HISTORIC AND DESIGN REVIEW COMMISSION

January 18, 2023

HDRC CASE NO: 2022-593
ADDRESS: 109 W MULBERRY AVE
LEGAL DESCRIPTION: NCB 1768 BLK 3 LOT W 25 FT OF 17 & E 25 FT OF 16
ZONING: R-4, H
CITY COUNCIL DIST.: 1
DISTRICT: Monte Vista Historic District
APPLICANT: Steve Graham/HOMEUP LLC
OWNER: Mary Stopper/STOPPER MARY MARGARET
TYPE OF WORK: Front-yard fence, front-yard turf, driveway and apron, construction of a 10'x24' backyard shed, hardscaping (rear patio)
APPLICATION RECEIVED: December 22, 2022
60-DAY REVIEW: Not Applicable due to City Council Emergency Orders
CASE MANAGER: Jessica Anderson

PLOT PLAN FOR BUILDING PERMITS

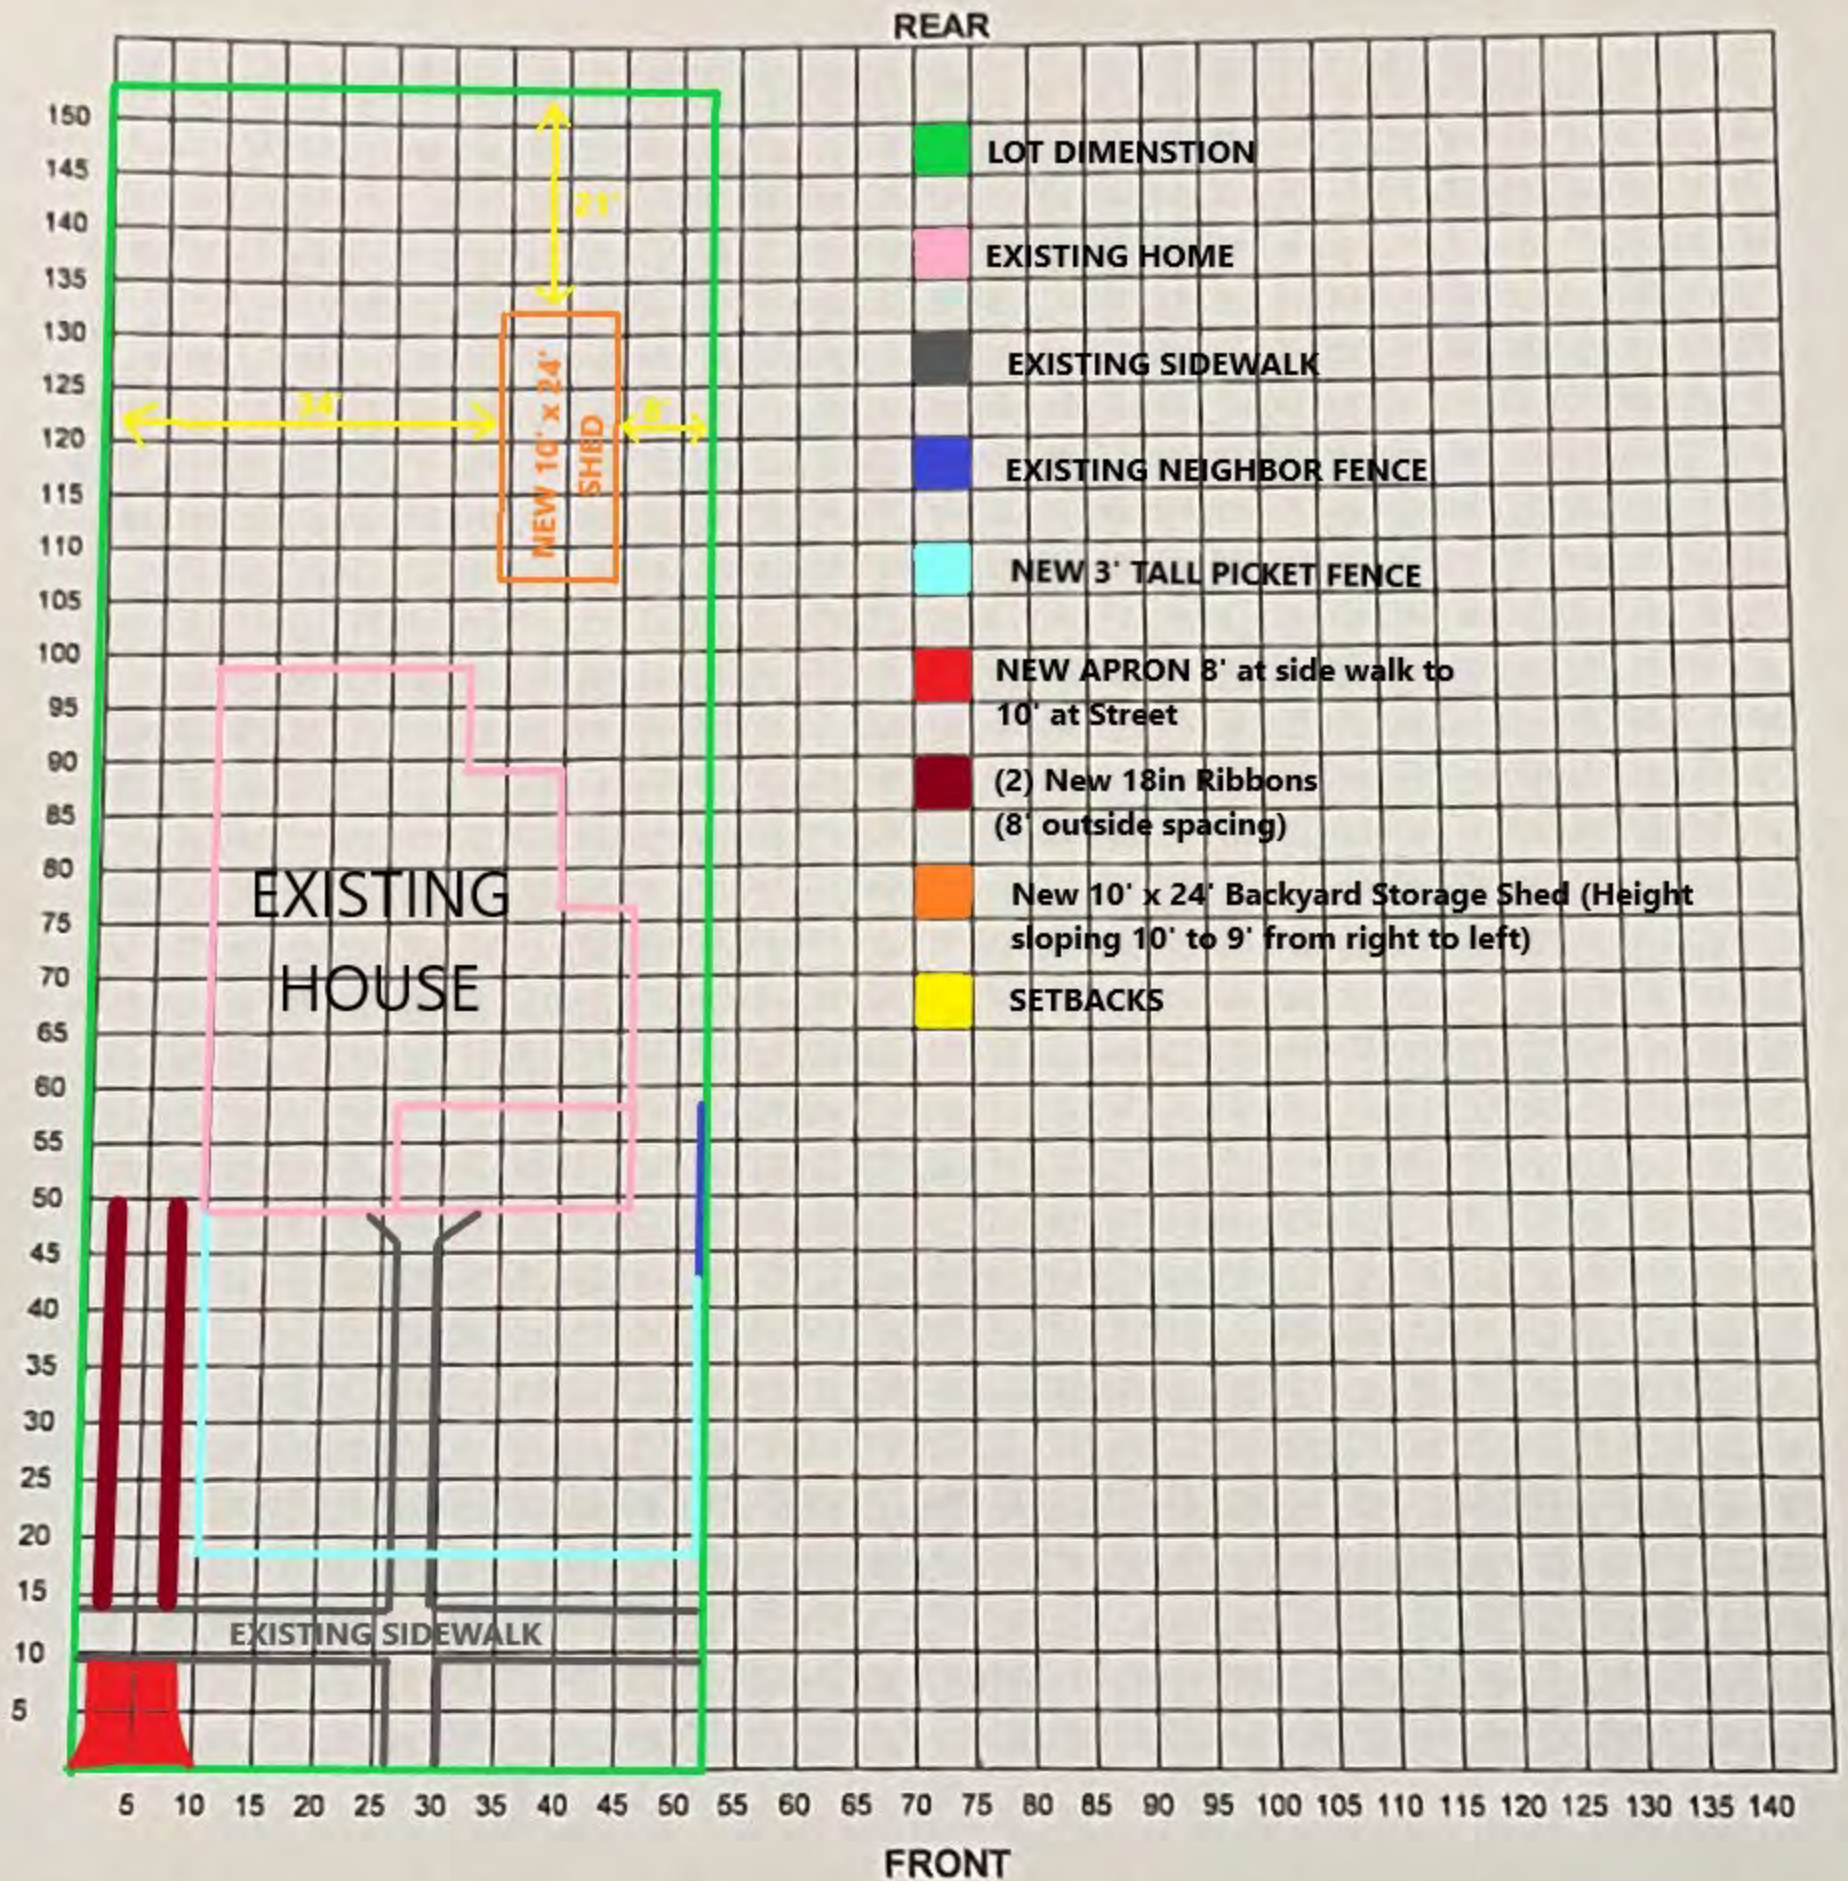
- c. DRIVEWAY: The applicant requests approval to add an 8'-wide concrete ribbon drive with an apron flaring from 8' at the sidewalk to 10' at the street. Historic Design Guidelines for Site Elements 5.B.i says to incorporate a similar driveway configuration—materials, width, and design—to that historically found on the site, and that historic driveways are typically no wider than 10 feet. Guideline 5.B.ii says avoid introducing new curb cuts where not historically found. Though the property did not historically feature a driveway, staff finds the 8'-wide ribbon driveway with apron that tapers to 10' generally appropriate.

- d. PATIO: The applicant requests approval to install a 15'x35' concrete paver patio next to the proposed backyard shed. Historic Design Guidelines for Site Elements 3.B.ii says new pervious hardscapes should be limited to areas that are not highly visible, and should not be used as wholesale replacement for plantings. The backyard is not visible from the right of way, and the rest of the yard will include gravel with plantings, as described in finding b. Staff finds the concrete paver patio generally appropriate.

Fetzer: Are the backyard pavers going to be on concrete slab or sand?

Graham: Sand.

Fetzer: Staff recommends approval of the pavers. Commissioners were concerned about impervious cover, but no concern since there's no slab.

Staff recommends approval of item 1, addition of an 8'-wide concrete ribbon drive with an apron flaring from 8' at the sidewalk to 10' at the street, based on finding c.

Staff recommends approval of item 2, installation of a 15'x35' concrete paver patio next to the proposed backyard shed, based on finding d.
